Case No. 2011-00128

Northern Kentucky Water District submits its responses to the Commission's data request of July 1, 2011. The application was filed on April 15, 2011 and included the critical timeline for the various stages of the project. As you may recall and as reflected in my letter to you of June 6, 2011, an order is needed by July 24, 2011 to assure that the lower than expected bids, which expire on August 31, 2011, do not expire.

1. Describe Northern District's current plans, aside from the proposed facilities, to expand the capacity of other facilities of the Taylor Mill Water Treatment Plant.

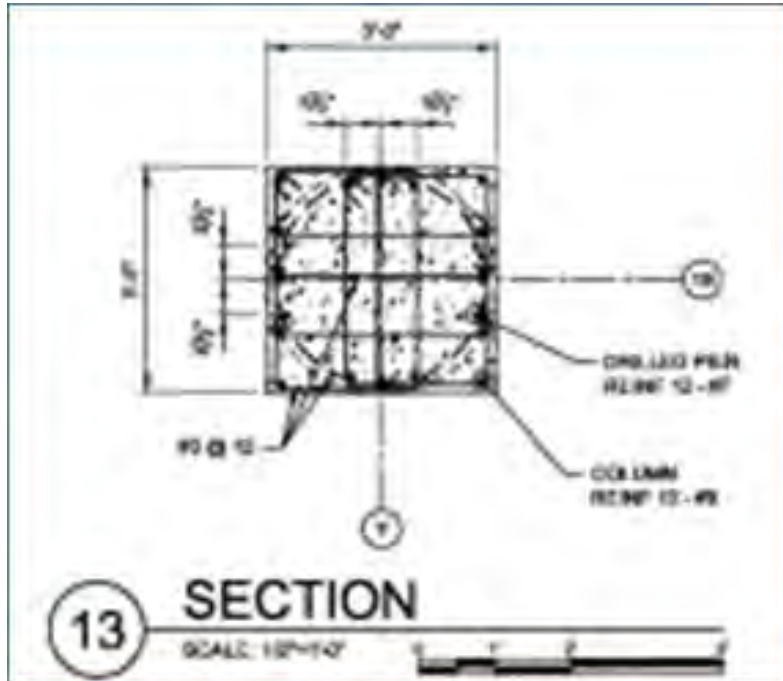
15. Refer to Plan Sheet S-06-301, Section 16. Section 16 shows a three-foot diameter drilled pier. The #7 steel reinforcement is distributed at four locations along the vertical and horizontal axes in a formation of three rebars spaced at five and one-half inches and totaling 12 rebars at a cumulative perimeter length of 44 inches. In the same cross-section, there also appear areas without any reinforcement for a cumulative perimeter length of 56 inches in the diagonal directions between the reinforced vertical and horizontal axes. Explain the rebar spacing in the cross-section.

Answer: A square column as shown in Sections 3 and 13 on sheet S-06-302 is sitting on the circular column shown in Section 16. The structural engineer designed the elements so that some of the rebar from the circular column would continue to the square column.
